**HUDSON RIVER PCBs REASSESSMENT RI/FS
RESPONSIVENESS SUMMARY FOR
VOLUME 2C-A LOW RESOLUTION SEDIMENT CORING REPORT
ADDENDUM TO THE DATA EVALUATION AND INTERPRETATION REPORT**

FEBRUARY 1999

**U.S. Environmental Protection Agency
Region II
and
U.S. Army Corps of Engineers
Kansas City District**

**TAMS Consultants, Inc.
TetraTech, Inc.**

Figure 4-10 (corrected)
Distribution of the Percent Change in
PCB Molar Inventory (Δ_M)

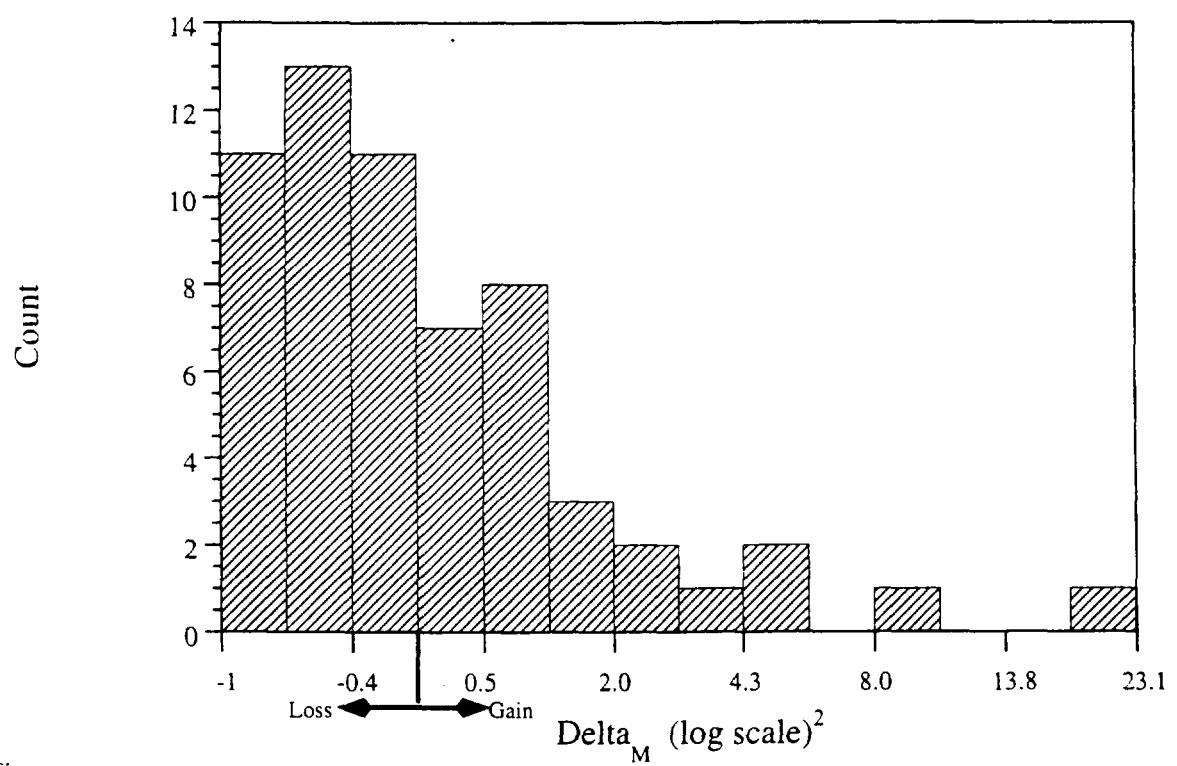
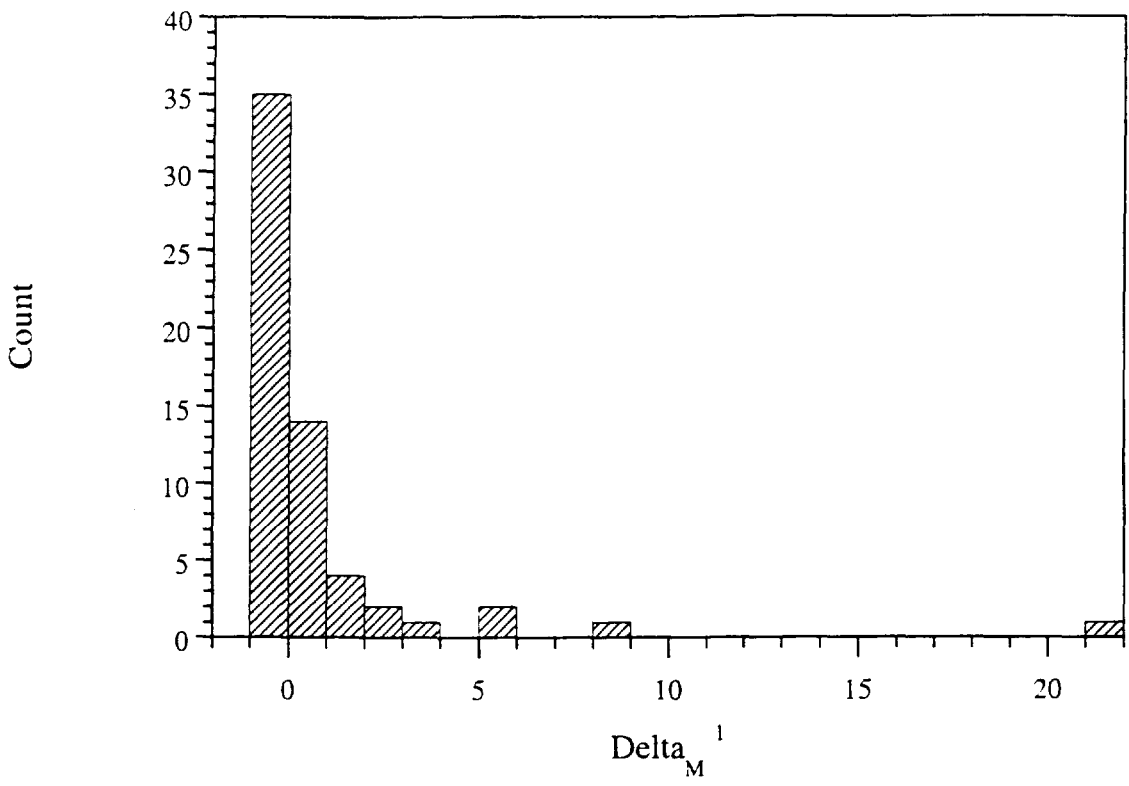
The x axis on the lower diagram in Figure 4-10 was corrected to show the correct values and units. It is included in this report.
